HISTORIC PRESERVATION COMMISSION

REQUEST FOR CERTIFICATE OF APPROPRIATENESS

MPC File No.: 26-002128-COA

Address: 937 West 38th Street

Item	Area
Main Building	864
A1 - 904:904-Slab Porch (SF) with Roof	52
A2 - 904:904-Slab Porch (SF) with Roof	84

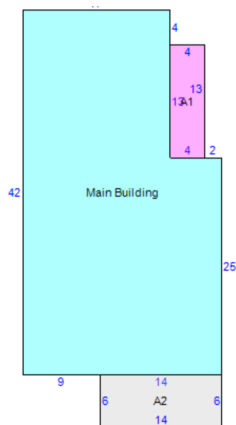
The applicant provided information stating there was 25% lot coverage, but staff requests further information on whether the provided 850 square feet is including the proposed addition. Also, from a visual perspective the site plan appears to cover more than 25% of the lot, thus more clarification is needed. Aerial views do not help in this case due to tree cover. There should be an existing and a proposed site plan showing the whole site, like the map view seen on SAGIS (page 1).

The side setbacks follow those of the house and appear to be met. However, the rear yard setback is not met, as the site plan shows the addition going all the way to the fence line. Clarification is needed showing the entire lot on the site plan to ensure that the 20-foot setback is met.

The height, width, and scale of the proposed addition is equal to the house, with the width potentially going beyond the width of the house. This is what is shown in the rendering but not what is shown on the site plan. Clarification is needed.

- 1. Clarify whether the rear elevation is proposed for demolition or will be incorporated into the addition.**
- 2. Provide clear photographs of the rear of the house showing the rear yard as well.**
- 3. Provide elevation drawings that note materials.**
- 4. Consider installing a different sized siding to help differentiate the old from the new construction.**
- 5. Lower the roofline so that the addition is subordinate to the historic house.**
- 6. Clarify whether the side elevation is visible from West 38th Street and if so, confirm on the drawings that the windows meet the 30% minimum for fenestration.**
- 7. Align windows and door on the rear elevation for visual compatibility compliance.**
- 8. Select an approved window type, as vinyl is prohibited.**
- 9. Provide material and product specifications for the door.**
